SB Number:	SB 3JY-001	Creation Date: 03/08/2006
Subject:	Remarks when replacing a SPACER FINISHER	
Model:	DF-710

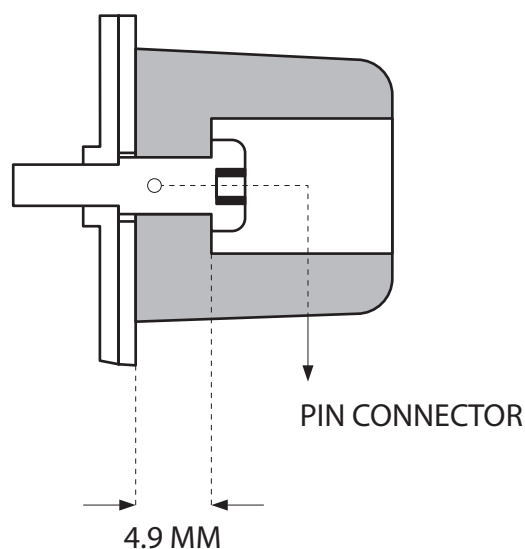
When fixing the SPACER FINISHER, it should be fixed by PIN CONNECTER, instead of a SCREW and a WASHER. Due to the above change, the shape and measurements of the SPACER FINISHER is changed.

When replacing the parts, please use the new part 'PIN CONNECTOR' only to fix the new SPACER FINISHER (Do not affix the old SPACER FINISHER).
